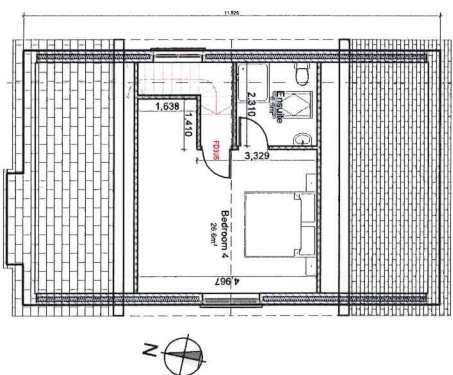
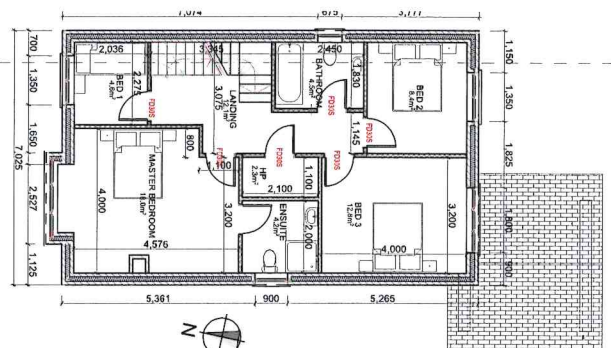
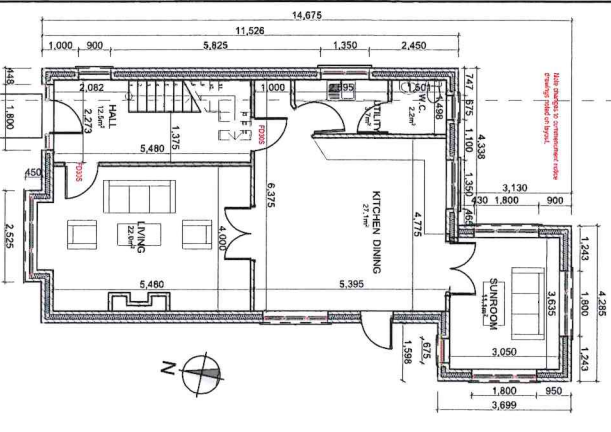
- ALTERATIONS TO DRAWINGS WHICH WERE SUBMITTED AT COMMENCEMENT NOTICE STAGE:
1. Utility and W/C. have been relocated to the left hand back corner of the dwelling. W/C. still complies with Part M of TGD's.
 2. Sunroom has been extended as per current drawings - Planning retention was granted for this amendment.
 3. Kitchen - Dining room has been redesigned since commencement drawings.
 4. Large Bathroom at first floor level has been relocated as per drawings.
 5. Hot Press has been relocated at first floor level.
 6. Attic Space has been converted to a 4th bedroom with en-suite with new stairs from first floor level to attic level. The stairwell has been enclosed in 30 mins fire rated construction and fire doors provided as per Part B of TGD's
